Subject: EBDU Well Locations

Apache Corporation

EBDU #37

Incident NDHR1922141227 (1RP-5636)

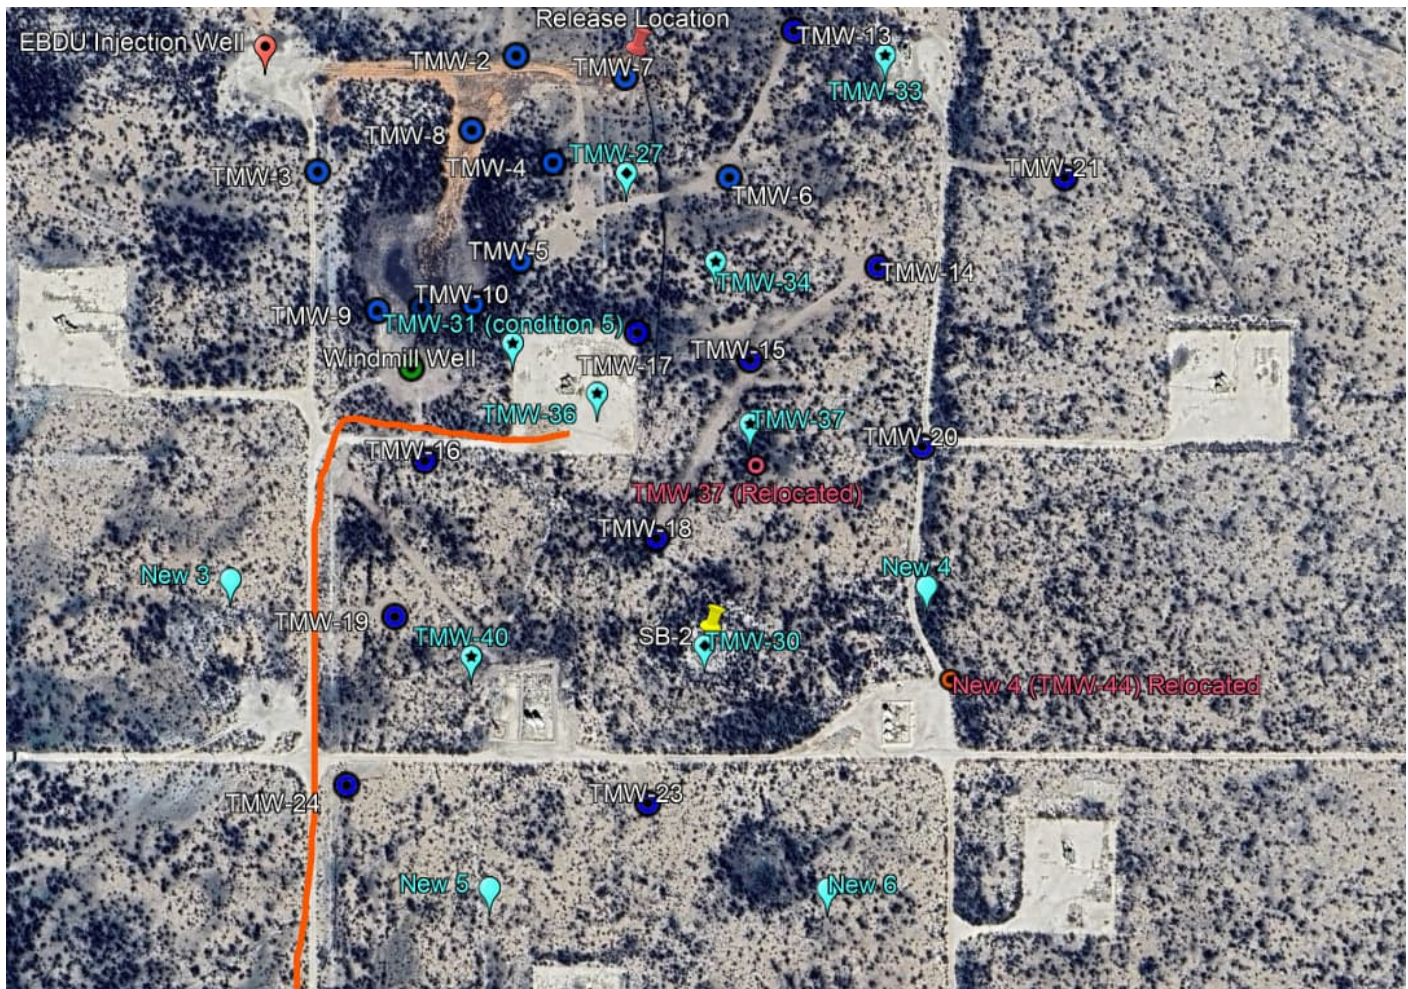
The purpose of this note is to request your approval of minor adjustments to two specific well locations due to safety concerns related to on-ground pipelines at the site. A screen shot showing the two locations (shown in red) is included below.

1. TMW-37 was moved approximately 30 feet southeast to avoid a Targa gas pipeline. The new location is proposed to be: 32.478510°, -103.119800°.
2. The well referred to as "New 4" was moved approximately 140 feet South-Southwest to avoid a cluster of poly lines in the area. It turns out there are several poly lines running along both sides of the access road where we had placed New 4, so we propose to move it south to the Northeast corner of the pad around the tank battery. The new location is proposed to be: 32.477303°, -103.118500°

The new locations are approved as follows:

1. TMW-37 moved approximately 30 feet southeast to avoid a Targa gas pipeline. The new location is proposed to be: 32.478510, -103.119800.

2. The well referred to as "New 4" moved approximately 140 feet South-Southwest to avoid a cluster of poly lines in the area. The new location is proposed to be: 32.477303, -103.118500.
3. New 1 (TMW-41) due to a combination of poly lines, fence, and overhead electric lines. The location has been shifted 160 feet to the Southwest to coordinates: 32.482125, -103.119904.
